October 29, 1985
ST-HL-AE-1480
File No.: G9.17

South Texas Project
Units 1 and 2
Docket Nos. STN 50-498, STN 50-499
Responses to DSER/FSAR Items
Concerning Chapter 7 on Safety-Related Display Instrumentation

The attachment includes mark-ups of FSAR pages which will be incorporated in a future FSAR amendment unless otherwise noted below.

<u>Attachment</u>	<u>Item No.*</u>	<u>Subject</u>
1	F 7.5-1 F 7.5-21 F 7.5-22	Safety-Related Display Instrumentation

ECW VALVES TO ESSENTIAL CHILLERS (2)

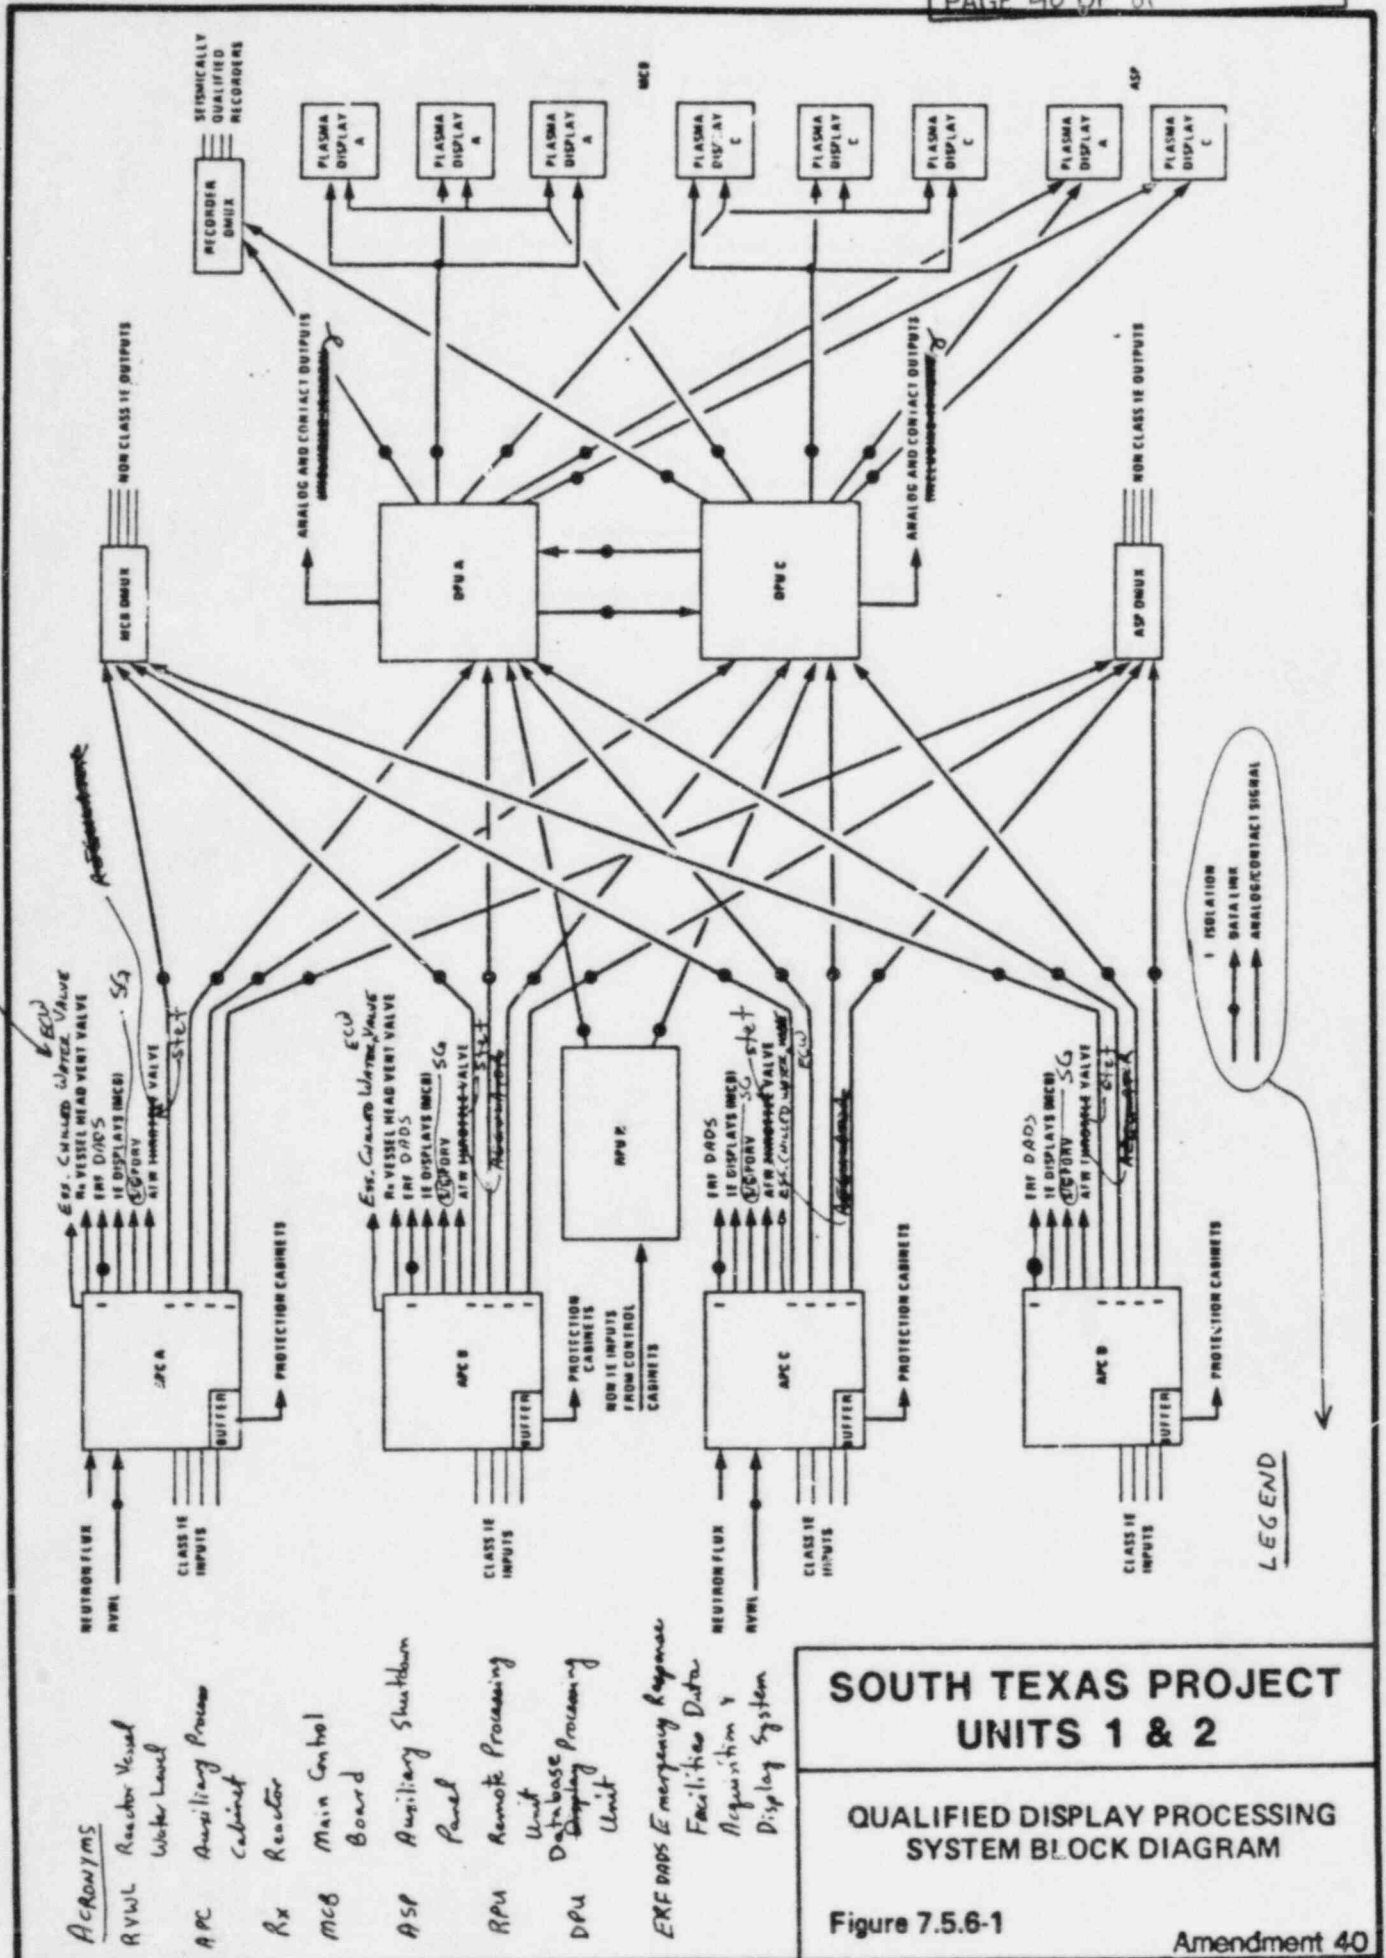
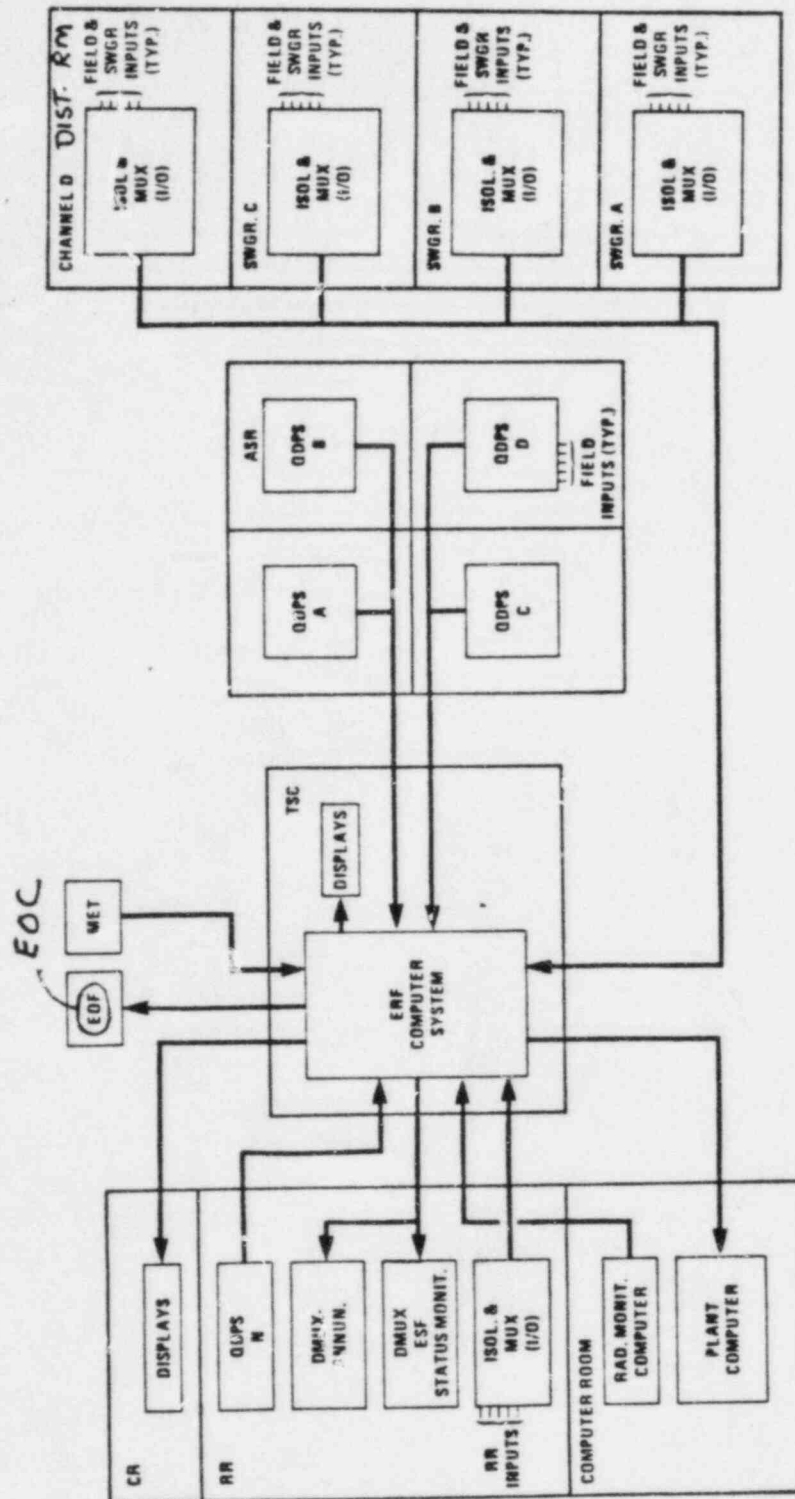
3. Open-loop control and position indication for the reactor vessel head vent valves.
4. ^{Analog} Closed-loop control and position indication for ECW flow control to the essential HVAC chillers. The SG PORV control equipment provides hardware to meet the requirements for full valve control including transfer, without position change, of operation from the control room to the auxiliary shutdown panel. A separate transfer switch selects the active control station. Each control loop accepts the steam line pressure, valve position, and the setpoints as input variables and outputs a 4-20 mA signal to control the valve.

The essential ^{cooling} ~~chilled~~ water (ECW) ^{flow} ~~water~~ control ^{to the essential HVAC} ~~equipment~~ provides hardware to meet the requirements for ^{full analog} ~~valve~~ control based upon essential chiller condenser pressure. The hardware provides the capability for transfer, without position change, of operation from the main control room to the auxiliary shutdown panel. A separate transfer switch selects the active control station. Each control loop accepts the essential chiller condenser pressure, essential chiller compressor run status, valve position and the setpoints as input variables and outputs a 4-20 mA dc signal to control the valve.
